**Planning & Zoning Commission
Agenda
Wednesday, January 18, 2023, 7:00 p.m.
Kirkwood City Hall
139 S. Kirkwood Road
Kirkwood, MO 63122
Posted January 13, 2023**

**CITY OF KIRKWOOD
PLANNING AND ZONING COMMISSION
SUBCOMMITTEE REPORT
JANUARY 18, 2023**

ACTION REQUESTED: SPECIAL USE PERMIT (VEHICLE SALE AND RENTAL) AND MAJOR SITE PLAN REVIEW – AUDI KIRKWOOD

Re: Audi Kirkwood – Site Plan Review (Major) & Special Use Permit

Sheet No: L1.01

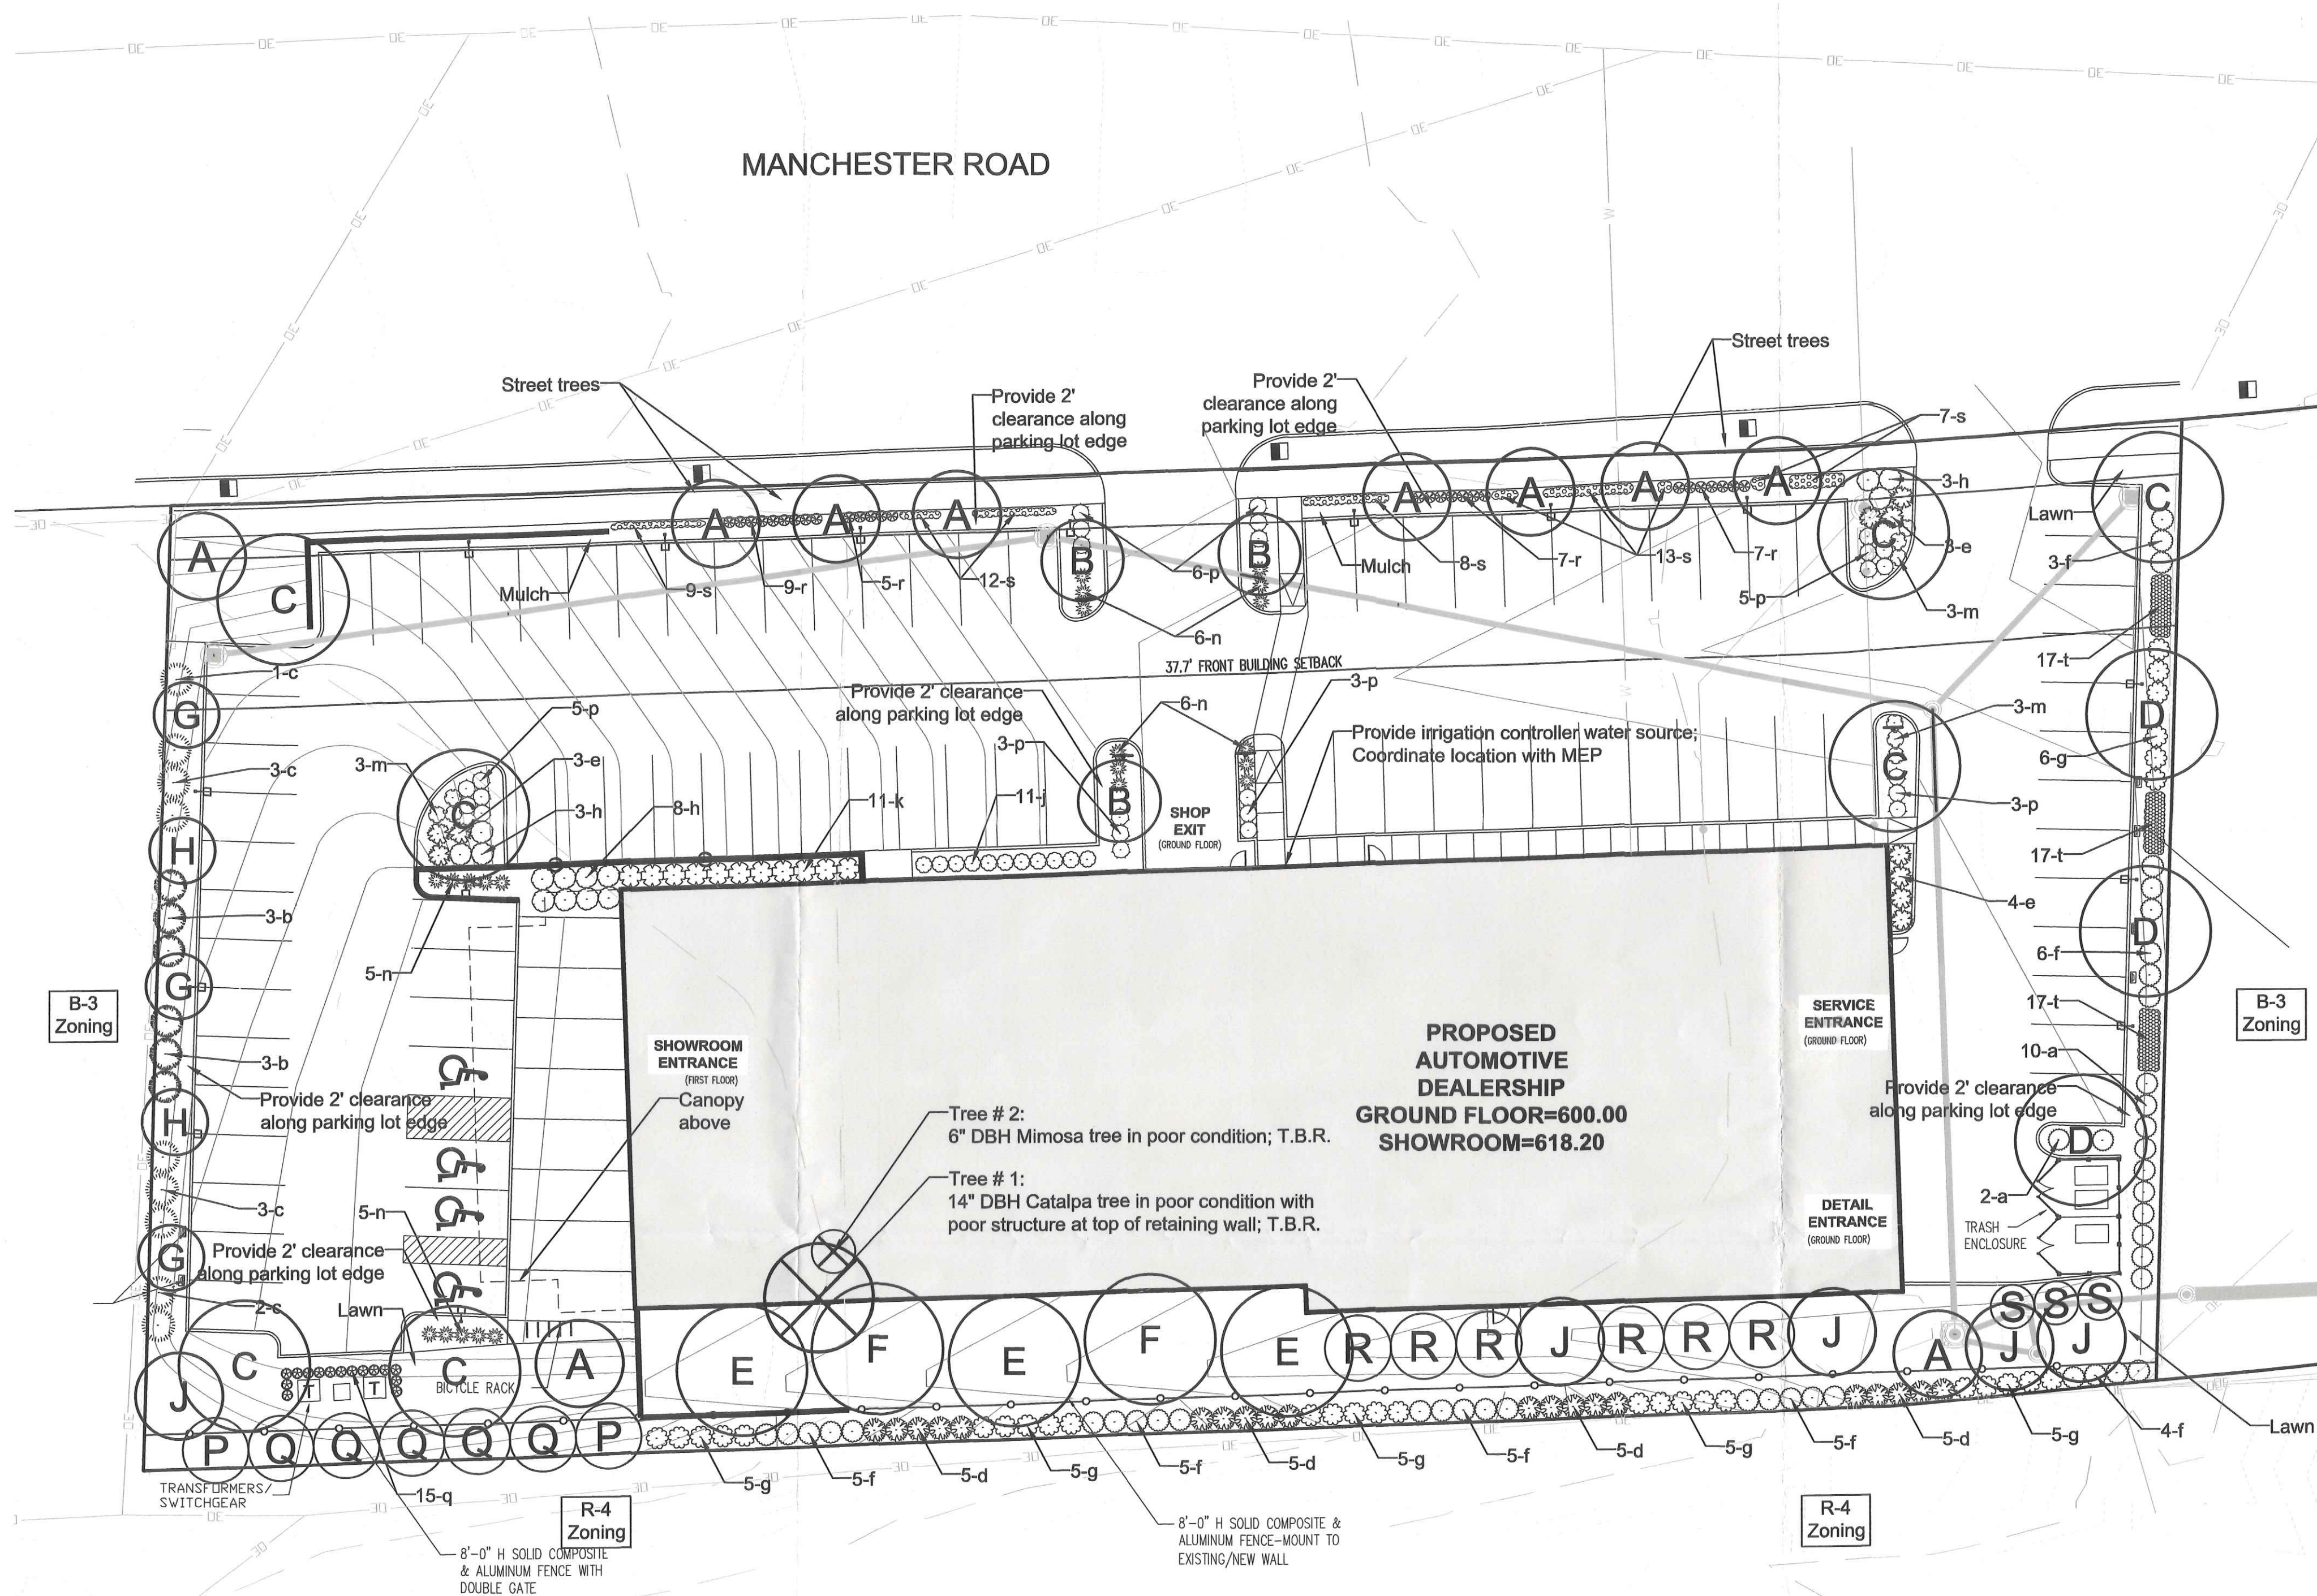
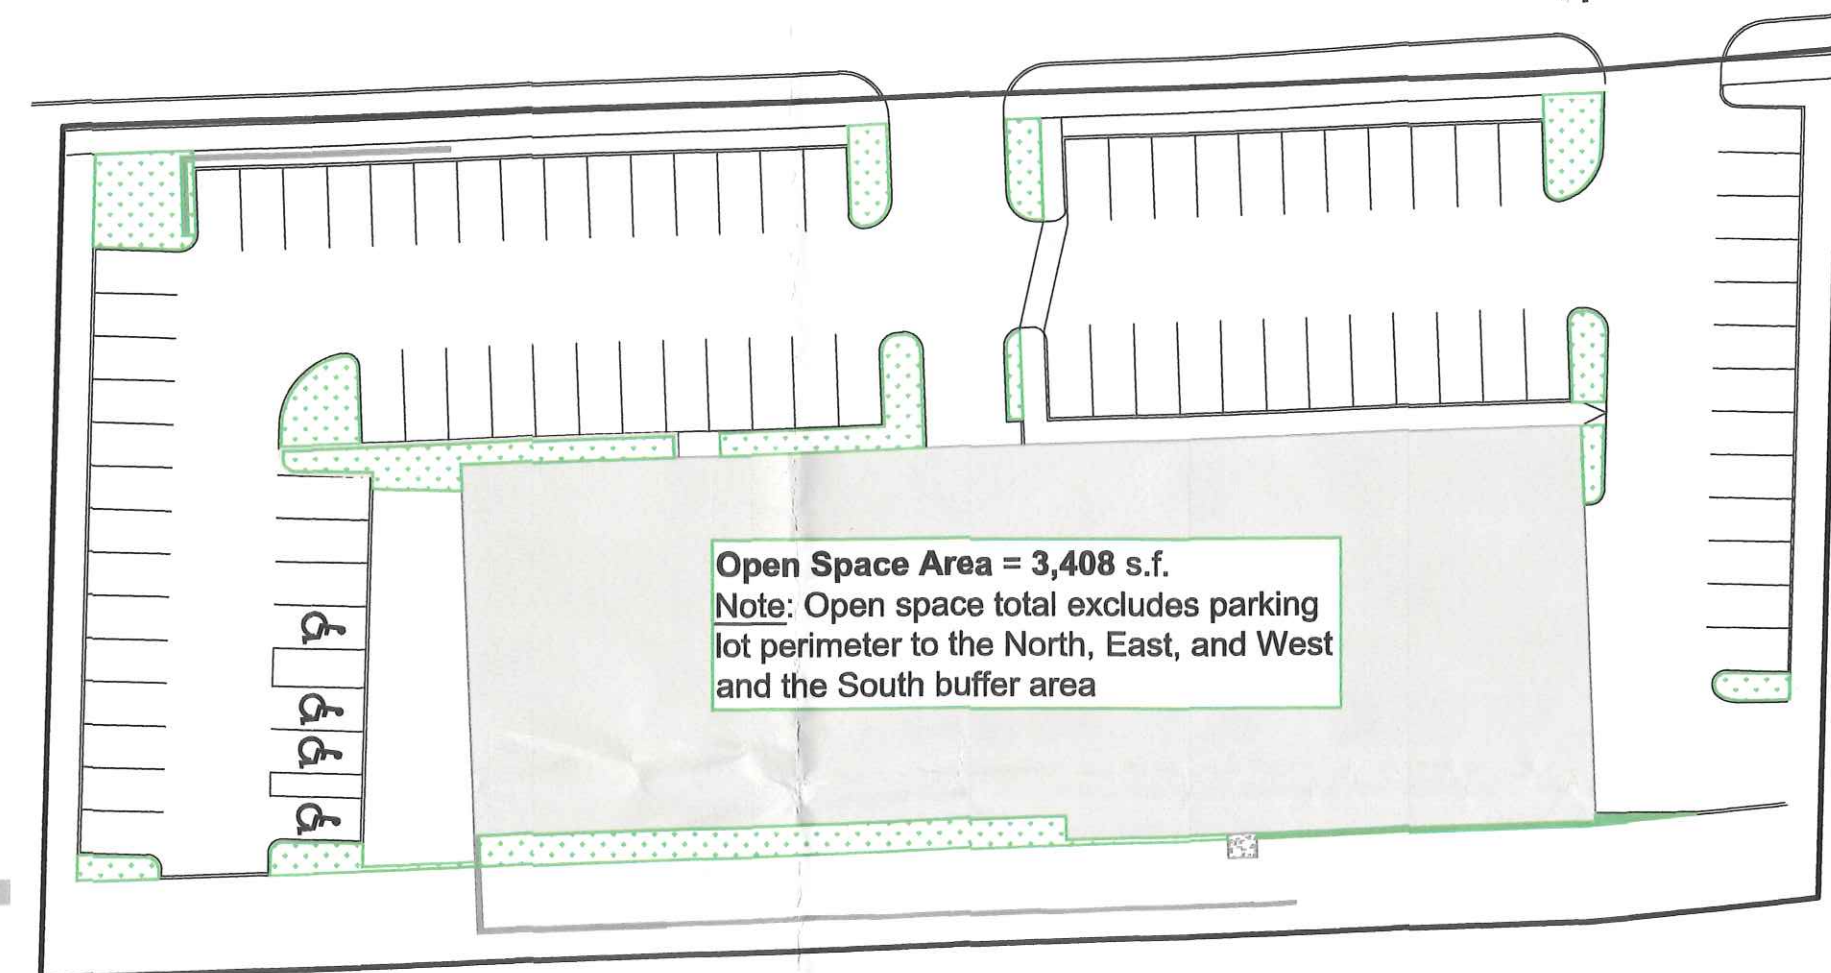
1. The modifications requested for the required 10' landscaped area along the north front lot line; the requirement for parking lot interior curb islands of at least 7' wide with 1 canopy tree; and the parking deficit of 9 spaces. The landscape plan will be resubmitted to the City with requested changes.

- c. The required curb island width and area for tree planting on the east side of the shop exit shall be reduced to 3' wide and approximately 60 square feet, with 1 understory tree to be provided in the southeast of the building rather than in the island referenced.
